SF Sweaters Ltd. (9879)

04.June.2014

Identified Priority 1 Concerns

Overall Stability System

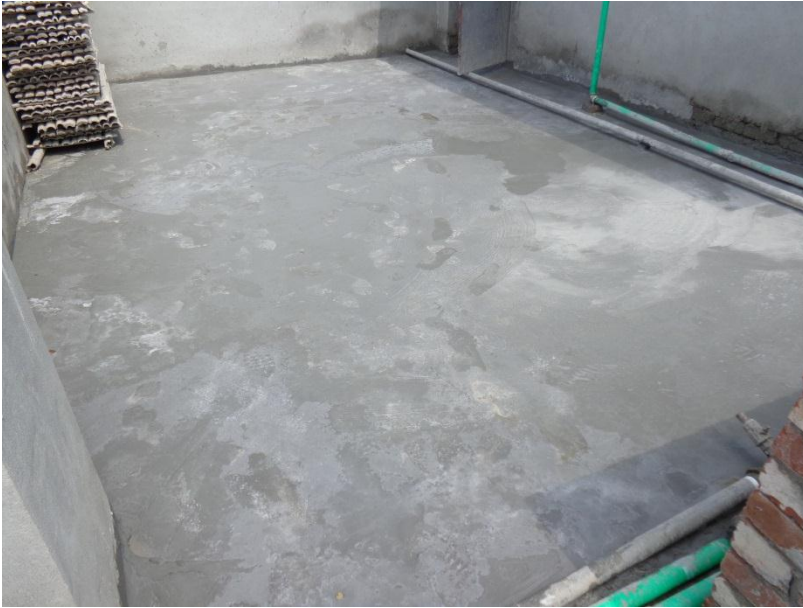
The building did not feature any core or shear walls. Stability was achieved through sway action between beams and columns and masonry infill walls.

We require that these items be investigated in a Detail Engineering Assessment
